P5022A-03A-S

Safety Service Note

P5022A Keysight Streamline USB Vector Network Analyzer

“POTENTIAL BURN INJURY (HIGH TEMPERATURE) HAZARD”

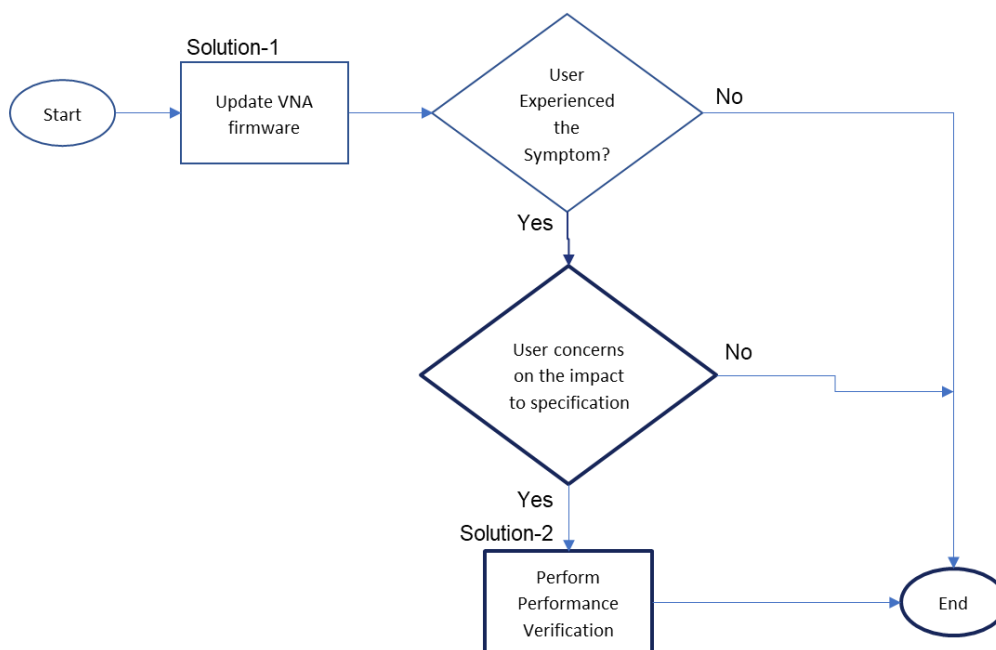
VNA fails to start with the following symptoms.

1. LED indicator (below circle) turns red.
2. cooling fan does not work
3. If user leaves the VNA with this LED indicator red without turning off power switch, it continues to overheat and becomes too hot.

Solution-1: Update VNA firmware by user

Solution-2: Perform Performance Verification by Keysight

1. **Install the latest VNA firmware Rev. A.15.55.14 or newer** on users' controller PC(s).
The latest firmware enhanced the thermal fan control mechanism.
2. Once the latest firmware is installed, proceed with the restart of both **controller PC** and **VNA**.
3. Launch the VNA firmware. Ensure VNA powers up and launches into firmware correctly after firmware update is done.
